## **Public Report GPvEM clarification sessions** ***Rolling Stock***

GPvEM Clarification Sessions September 2019

Author	ERTMS Program - DK
Reviewer	ERTMS Program - ML, KR, WJ
Released	ERTMS Program - MHB
Version	1.0
Date	22 January 2020
Status	Final

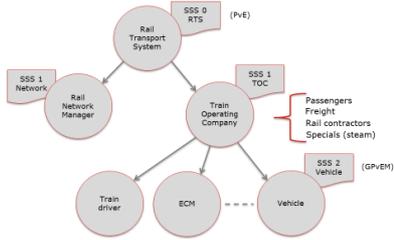
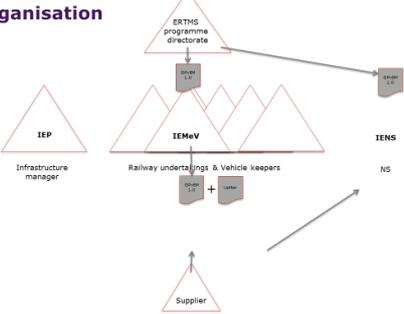
11. About requirements ETCS-2033 and ETCS-2011 dealing with the time to change from NP- to SB mode and from SB to an active mode, it was remarked that the required times will not be met; that brake test timing is rolling stock dependent; that RadioBlockCenter and GSM-R network components are outside the suppliers scope; that minimizing timing of the

safety purposed self-test is not recommended and it was asked whether the STM initialization is included.

The questions were discussed and answered, including that the RBC / network component and STM initialization are outside the scope of both requirements.
